SUBJECT: Triangle Expressway Southeast Extension (Complete 540) from NC 55 Bypass in Apex to US 64/264 (I-87) in Knightdale, Wake and Johnston Counties; Federal Aid No. STP-0540(19), STP-0540(20), and STP-0540(21); WBS Nos. 37673.1.TA1, 35516.1.TA1, and 35517.1.TA1; STIP Project Nos. R-2721, R-2828, and R-2829

From: [Williams, Andrew E CIV USARMY CESAW \(USA\)](#)
To: [Riffey, Deanna](#)
Cc: [Alsmeyer, Eric C CIV USARMY CESAW \(USA\)](#); [Matthews, Monte K CIV USARMY CESAW \(USA\)](#); [Williams, Andrew E CIV USARMY CESAW \(USA\)](#)
Subject: [External] SAW-2009-02240 R-2721A Individual Permit Modification--MOD9
Date: Tuesday, September 13, 2022 10:39:18 AM
Attachments: [R-2721A Permit Drawings 06292022.pdf](#)

Subject: MODIFICATION of 401 Water Quality Certification Pursuant to Section 401 of the Federal Clean Water Act, NEUSE BUFFER RULES, and ISOLATED WETLANDS PERMIT Pursuant to IWGP100000 with ADDITIONAL CONDITIONS for Proposed construction of the Triangle Expressway Southeast Extension (NC 540) in Wake & Johnston Counties, Federal Aid Project No. STP-0540(19-21), State Project No. 37673.1.TA2, TIP Nos, R-2721, R-2828, & R-2829.
NCDWR Project No. 20181249 version 10

PERMIT

PERMIT DRAWING
SHEET 24 OF 119

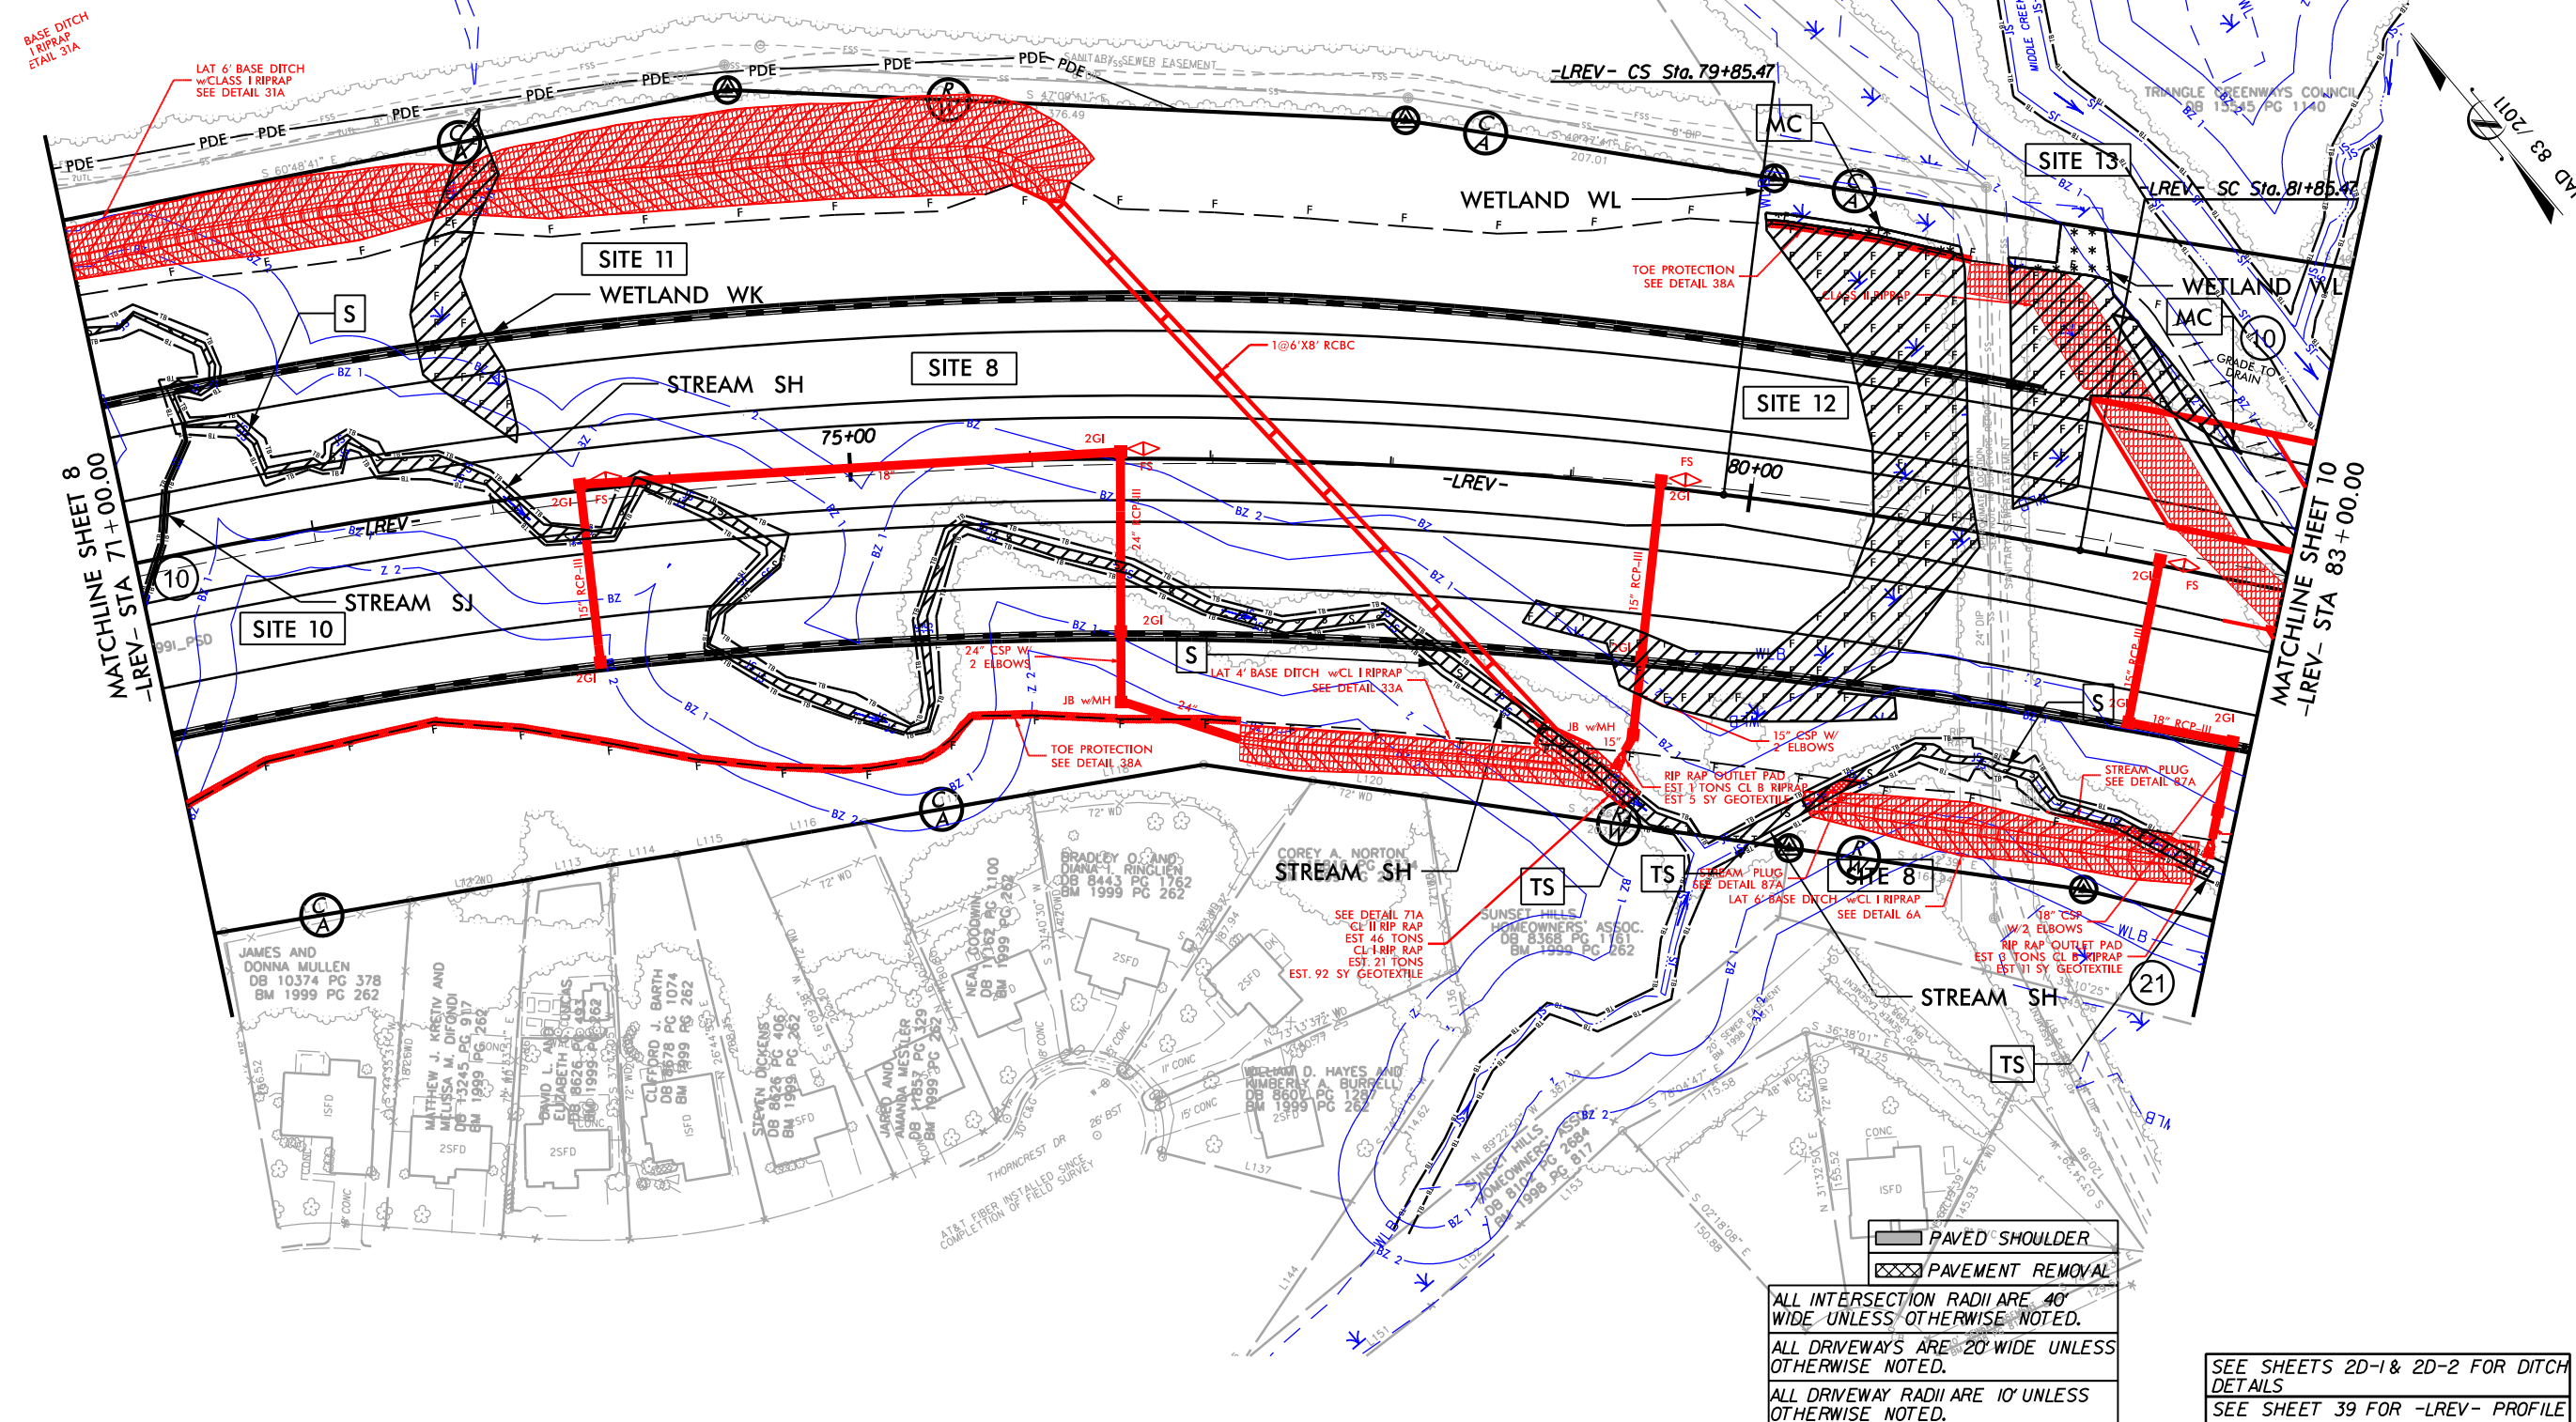
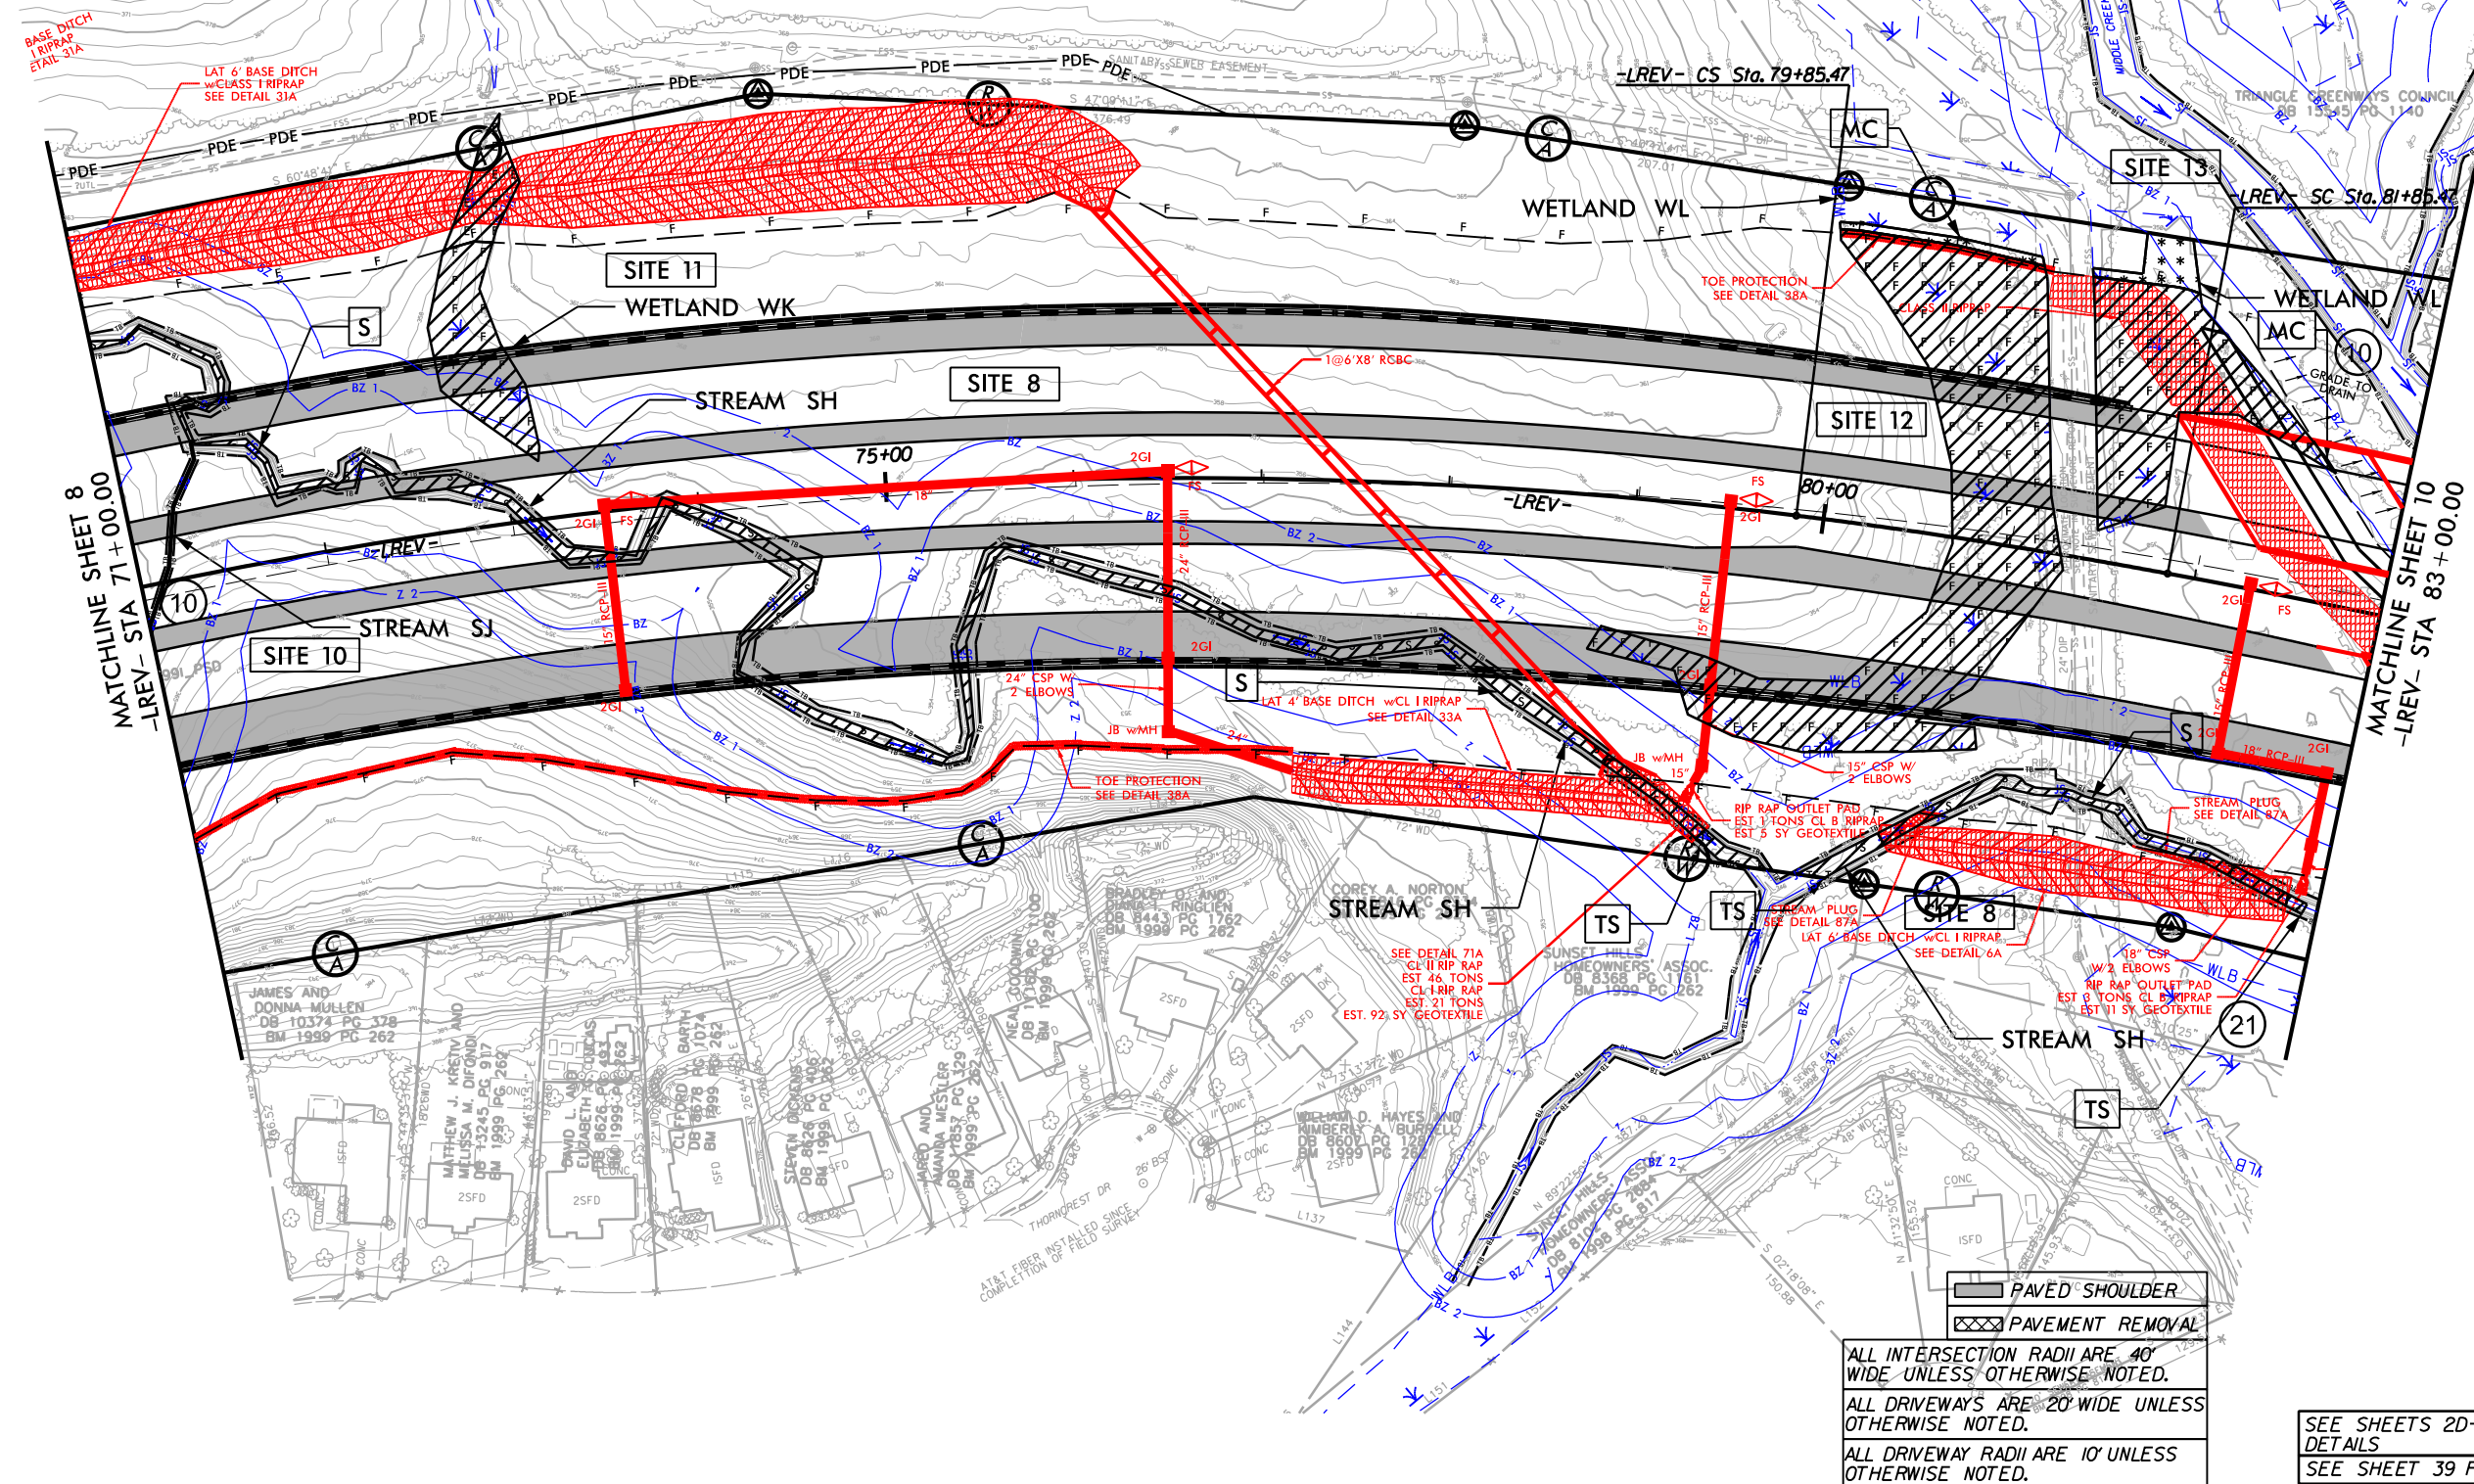
Site 12- 0.02 acre that were previously permitted as mechanized clearing would be permanently filled.

Site 13- 0.01 acre that were previously permitted as mechanized clearing would be permanently filled.

Site 12: 0.02 acres Mechanized Clearing changed to Permanent Fill.

Site 13: 0.01 acres Mechanized Clearing changed to Permanent Fill.

Revised Site 12 Total Impacts: 0.49 ac Permanent Fill. 0.01 ac Mechanized Clearing.

Revised Site 13 Total Impacts: 0.18 ac Permanent Fill. 0.02 ac Mechanized Clearing.
